Restoring the optical power levels for the 50GBASE-SR family

Piers Dawe

Mellanox

50 Gb/s per lane MMF baseline and earlier specs

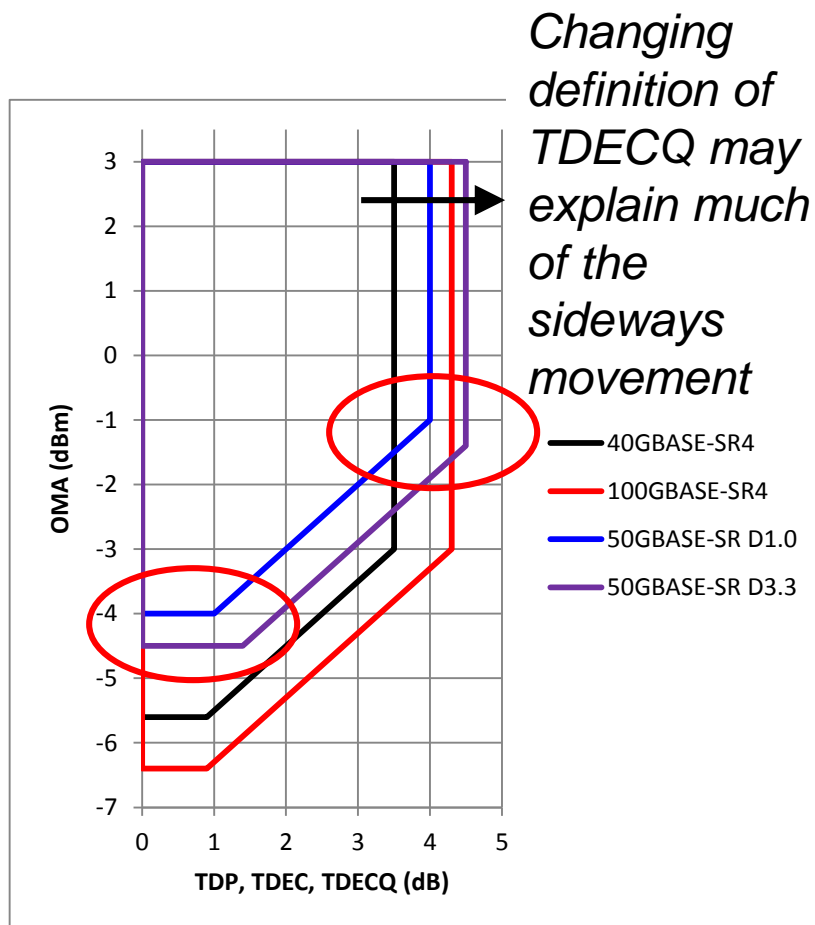
For a consistent worst signal, the OMA at max TDECQ should stay constant from draft to draft even as the definition of TDECQ changes
SRS OMA follows this (1.9 dB lower)

Somehow, the spec has drifted

- In D3.3, the min. OMA at max TDECQ, and the SRS OMA, were moved down by 0.4 dB
- This should not have happened
 - Our idea of a worst signal hasn't changed, but the TDECQ score it gets, has changed
 - king_3cd_01_0518 had proposed different changes to the ones adopted for D3.3
 - In D3.3 we aimed to correct a discrepancy introduced by the floating thresholds, but created a new error in the process

Restoring the optical power levels

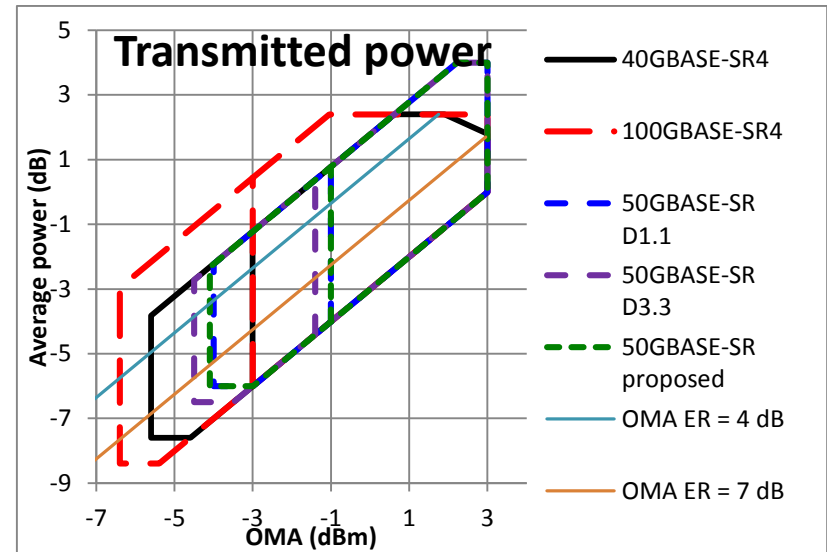
The changes on the left (green) restore the status quo within 0.1 dB, assuming today's TDECQ reads about 0.5 dB higher than the baseline's (4.5 vs. 4 dB)

- See next slide for the same in bigger type
- OMA-TDECQ from -5.9 to -5.5 dBm
- SRS OMA from -3.4 back to -3 dBm (as in the baseline and D3.2)
- Other receiver sensitivity, equation 138-1, from $\max(-6.5, \text{SECQ} - 7.9)$ to $\max(-6.1, \text{SECQ} - 7.5)$.
- Tx min OMA from -4.5 in D3.3 to -4.1 (nearly the -4 from the baseline);
- Min average power at Tx from -6.5 in D3.3 to -6 (back to the baseline);
- Min average power at Rx from -8.4 in D3.3 to -7.9 (back to the baseline)
